PROJECT: LITTLE ST. JAMES
SHEET TITLE: KITCHEN ELEV./SECTION
SHEET 5 OF 9

APPROVED AS NOTED 11.10.2010
MARK REFF

KITCHEN SECTIONS

SCALE: AS NOTED DRAWN BY KAS	PROJECT: UTILE ST. JAMES SHEET TITLE: ISLAND ELEV./SECTION SHEET 8 OF 9	REVISED:	DATE: 10/25/10 SHEET #: W-8
------------------------------	---	----------	--------------------------------

REVISED: DATE: 10/25/10
SHEET #: W-5

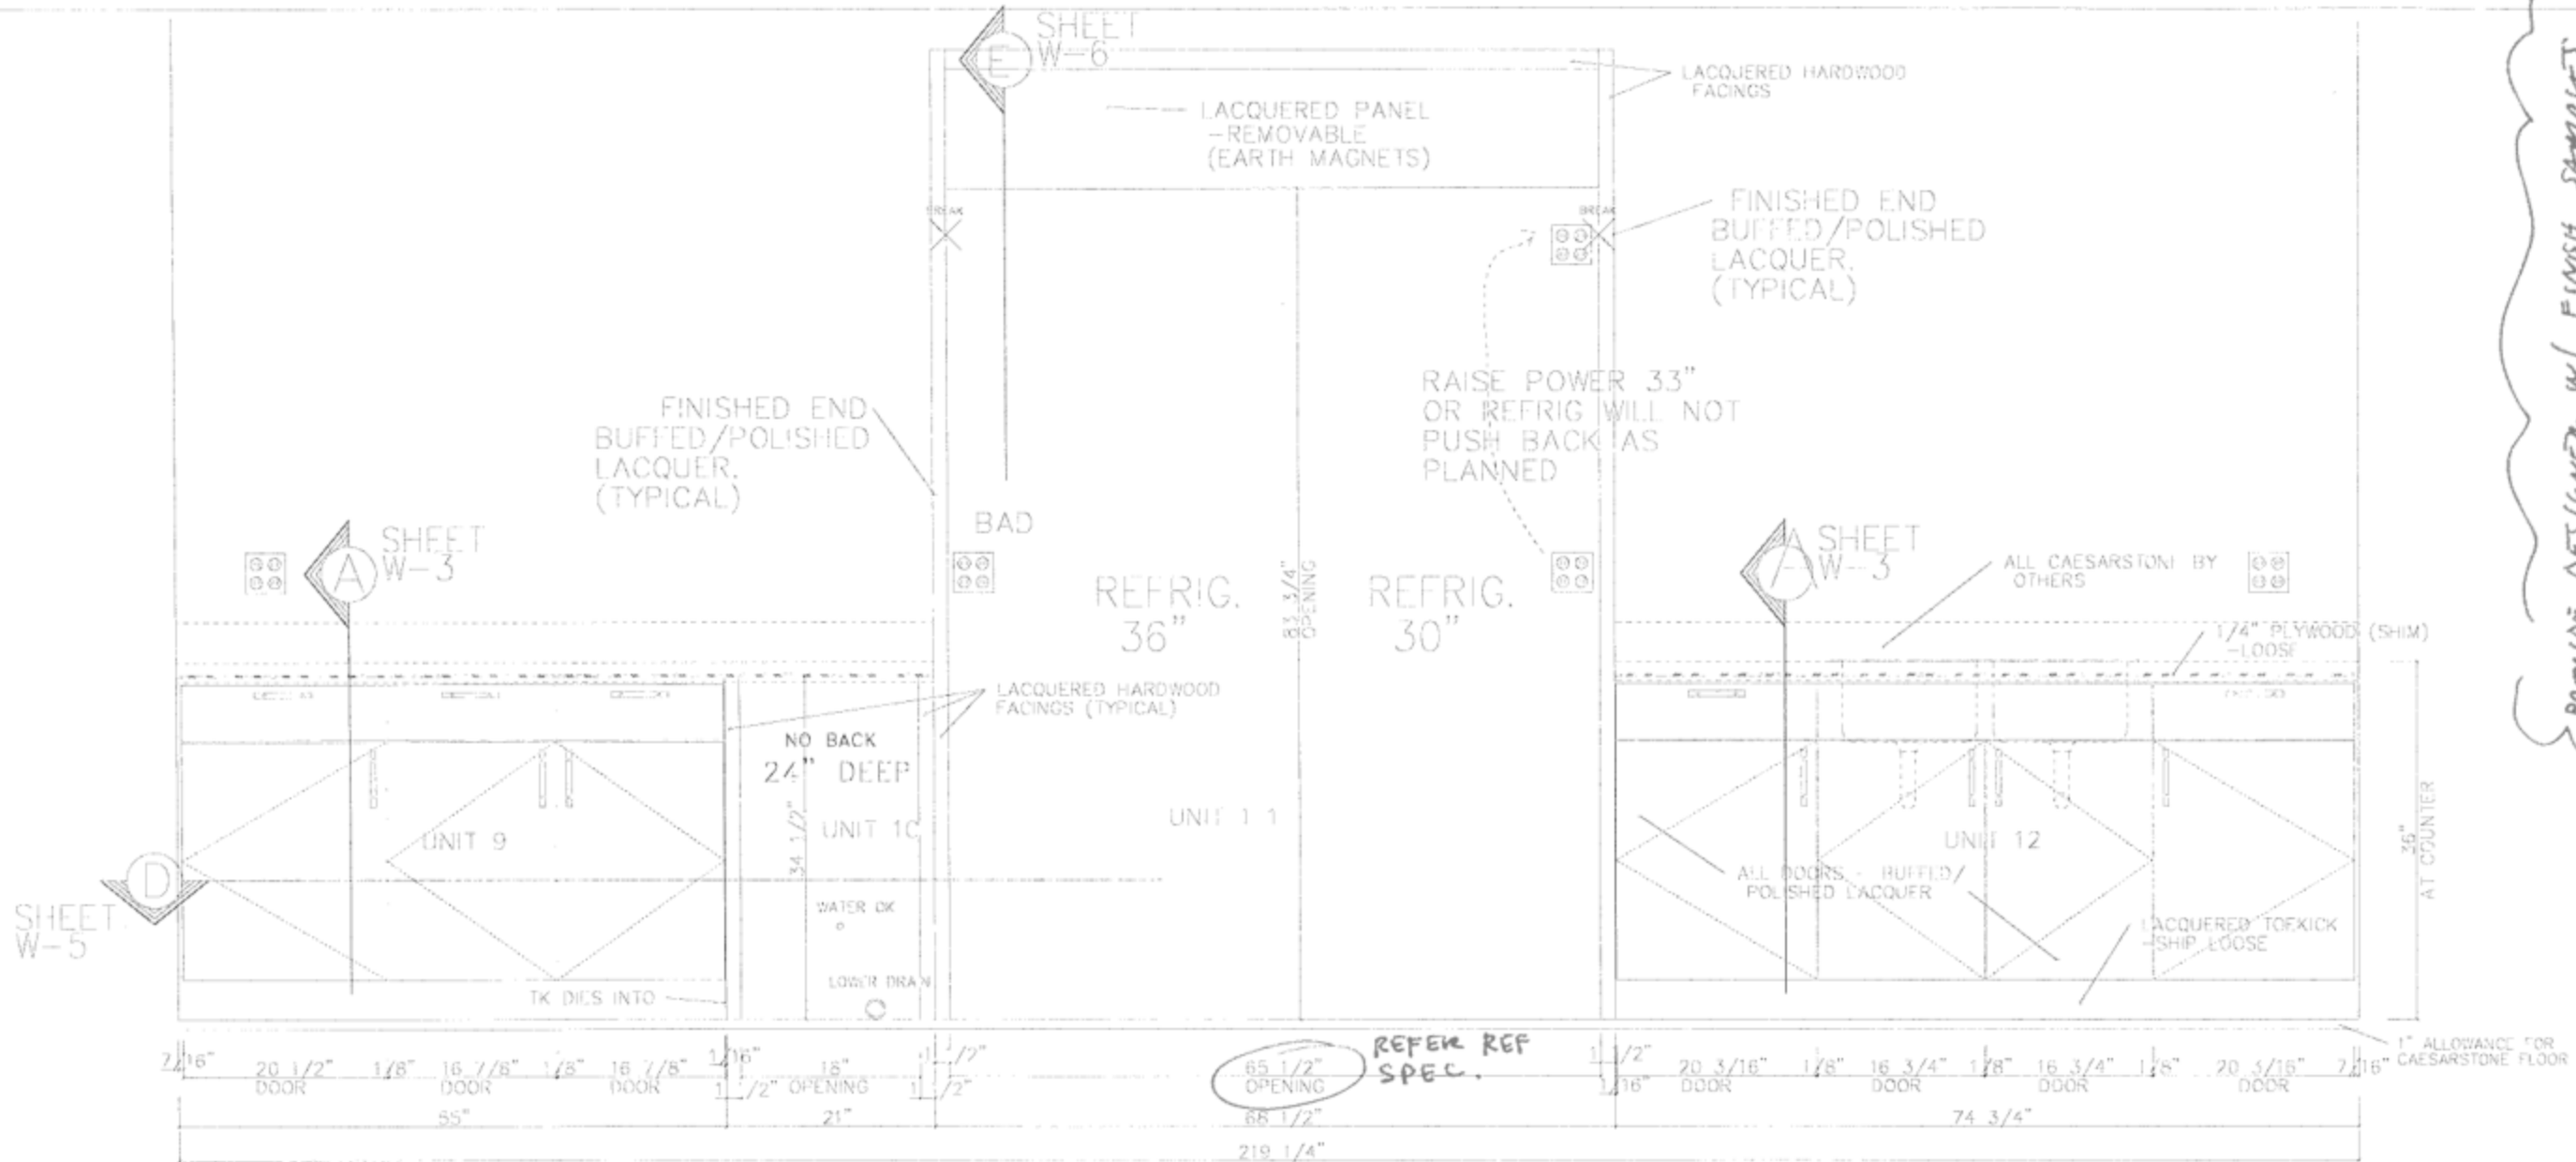
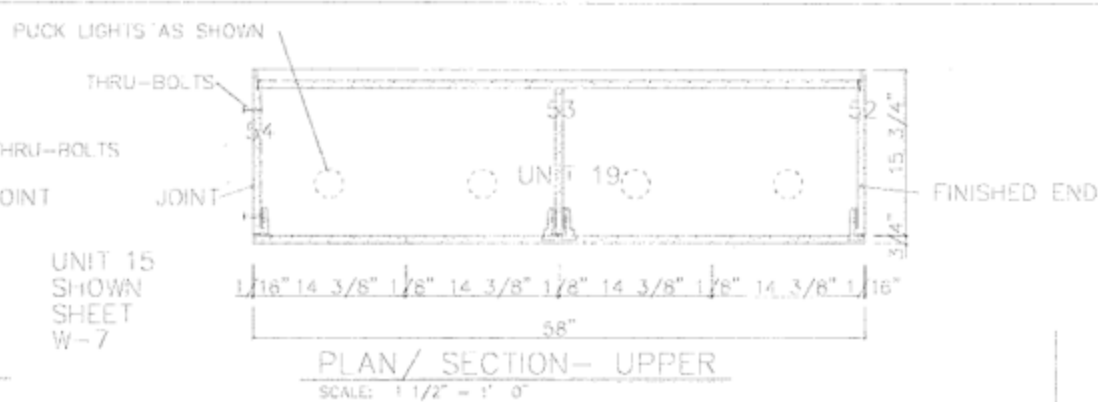
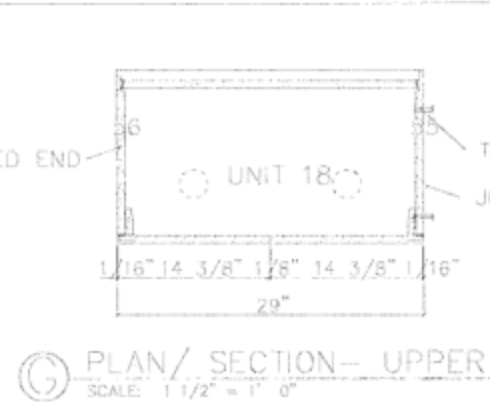
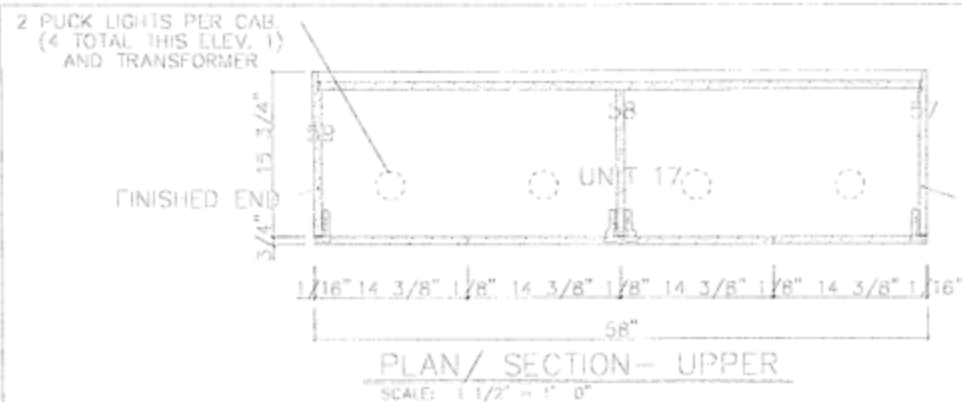
PROVIDE DESIGNER W/ FINISH SAMPLES
FOR APPROVAL PRIOR TO FABRICATION
OWNER TO APPROVE APPLIANCES
& PLUMBING FIXTURES.

PROVIDE DESIGNER W/ FINISH
SAMPLES FOR APPROVAL
PRIOR TO FABRICATION

OWNER TO APPROVE
ALL APPLIANCES.

W-6

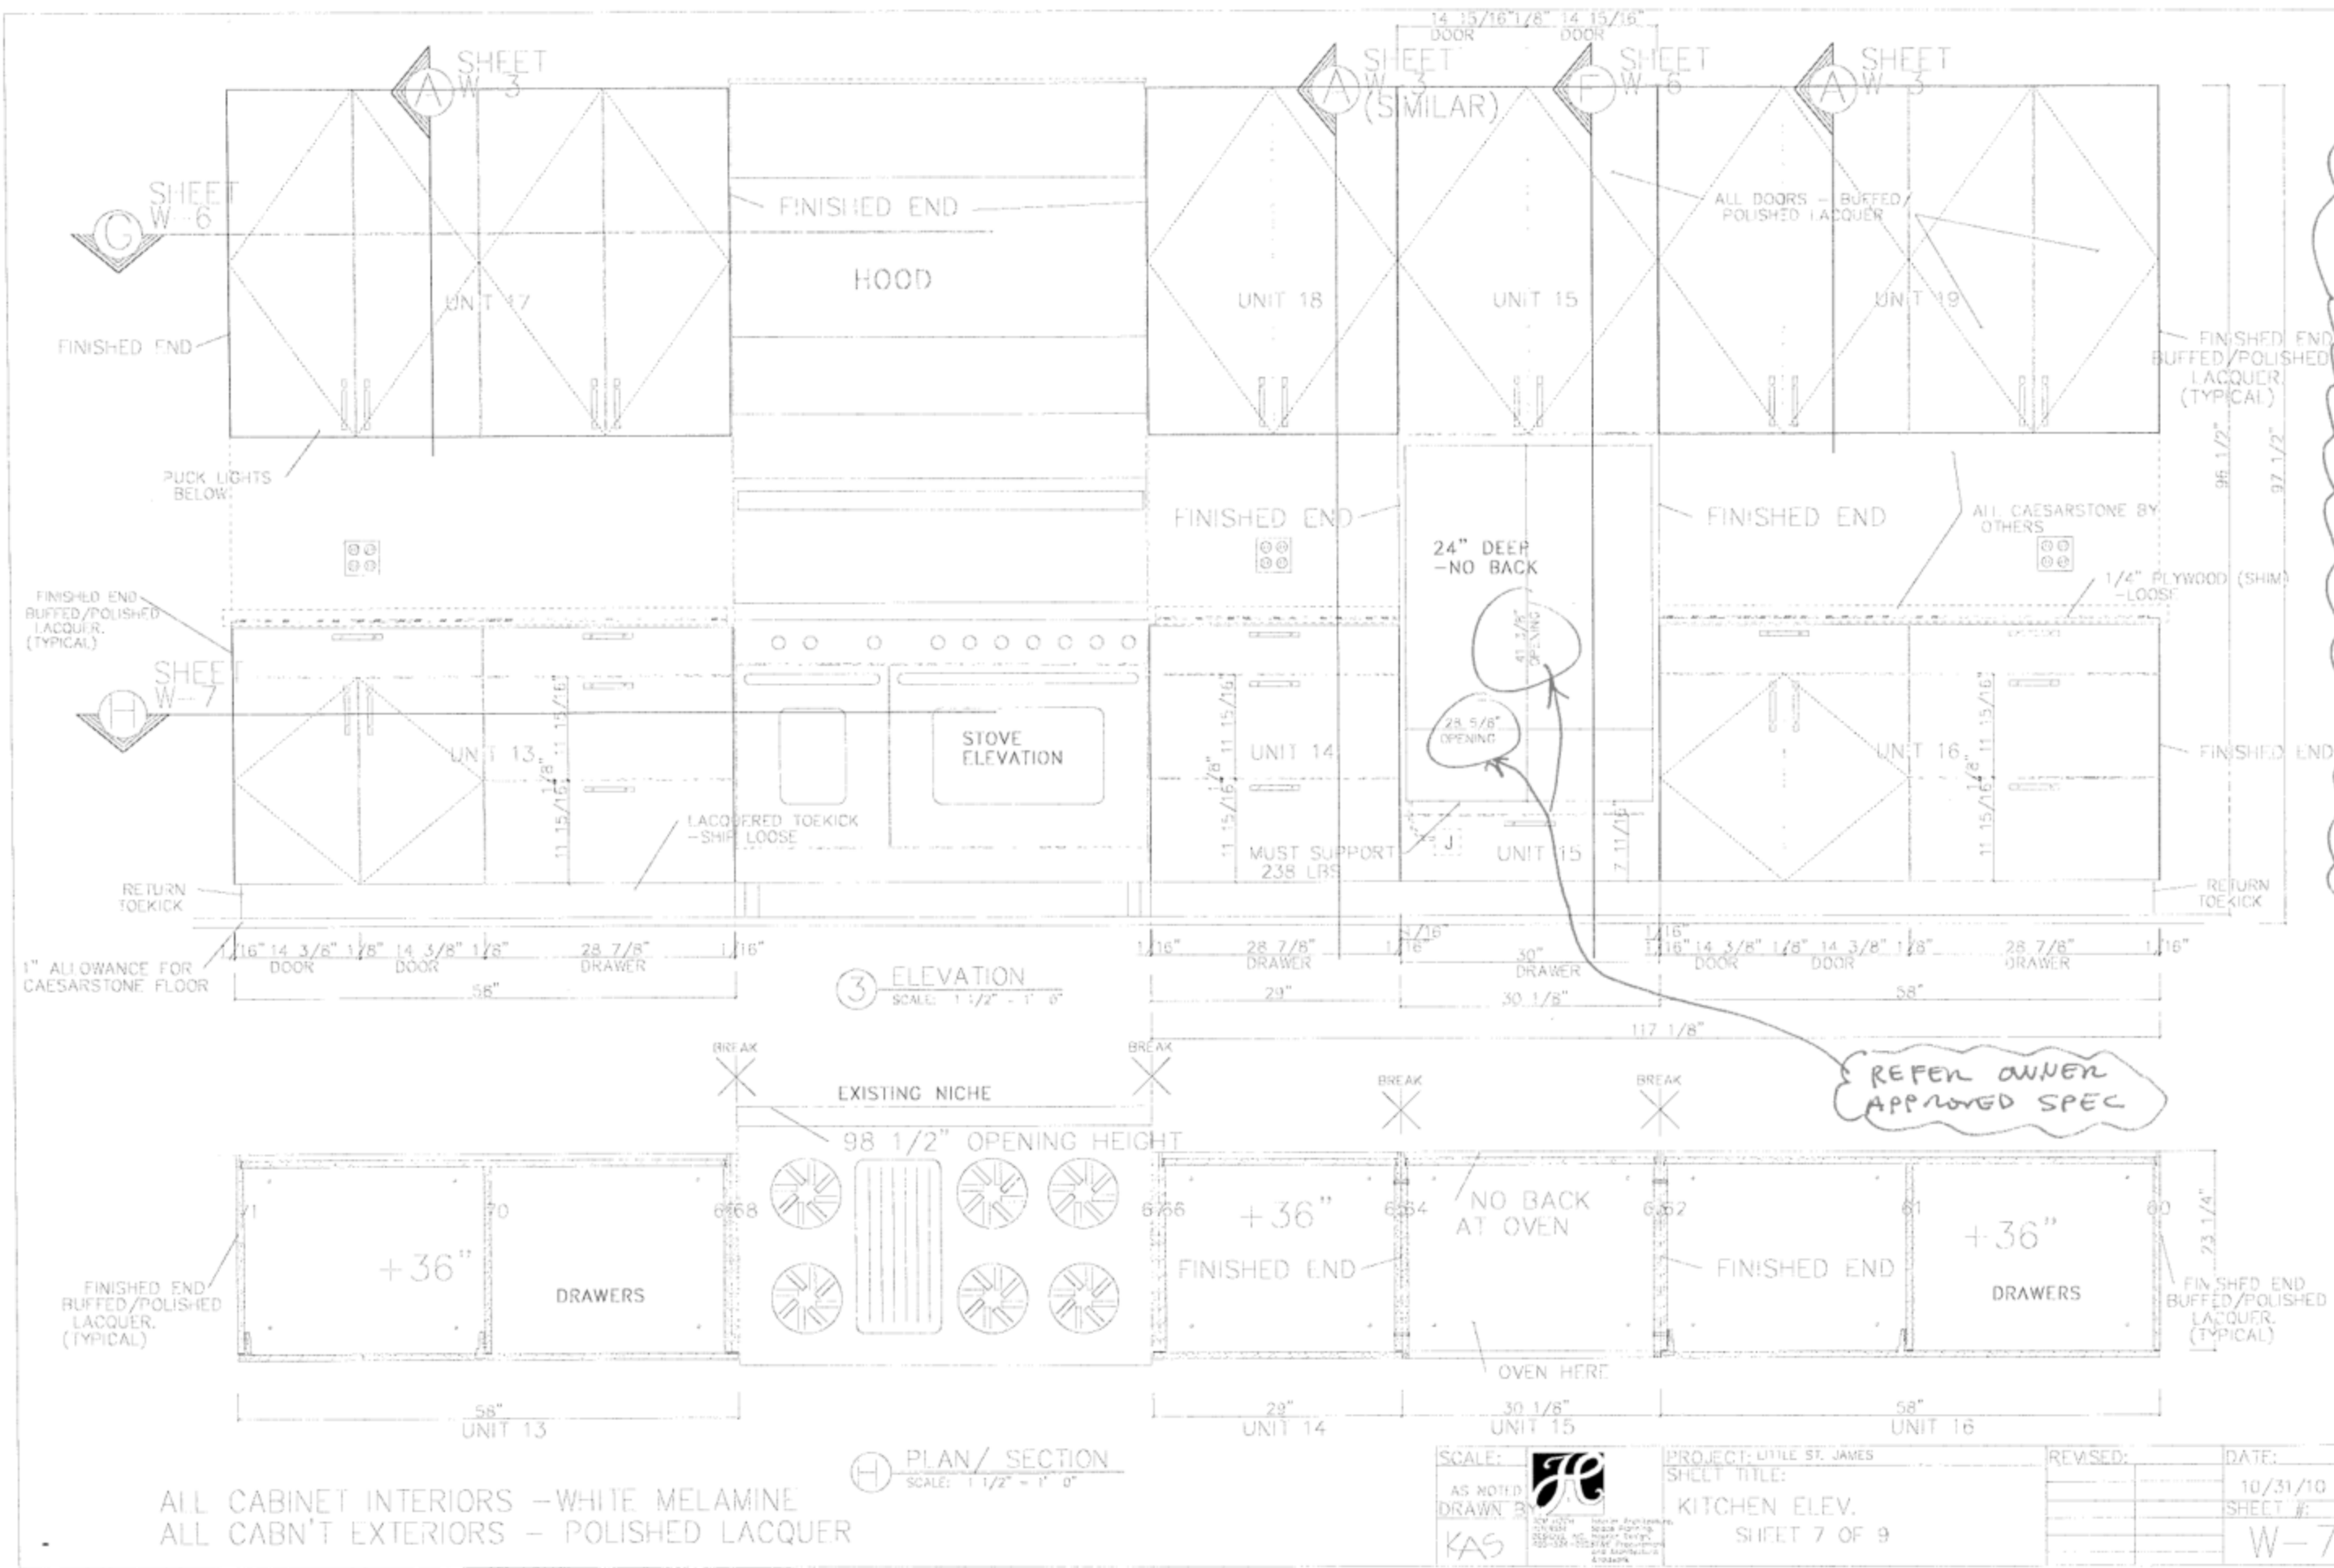
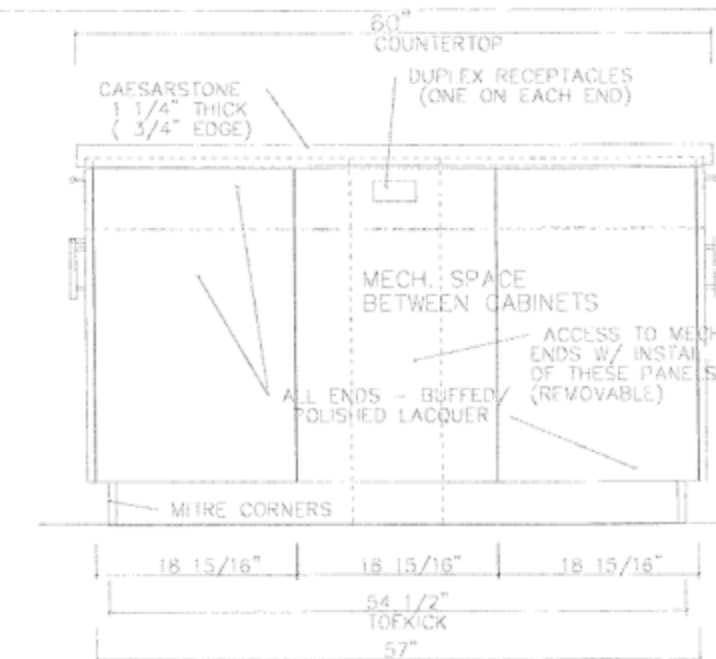
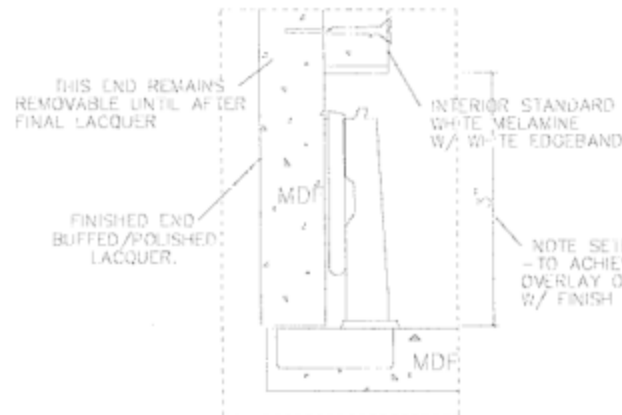
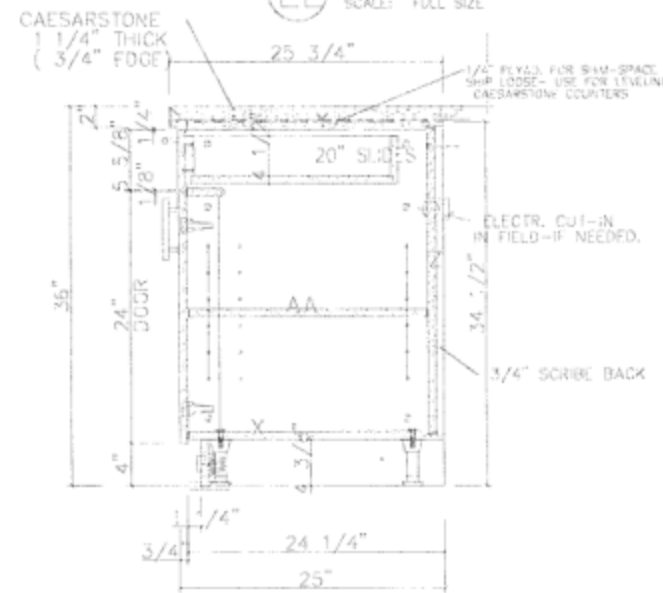
PROVIDE DESIGNER W/ FINISH SAMPLES FOR APPROVAL PRIOR TO FABRICATION.
OWNER TO APPROVE ALL APPLIANCES
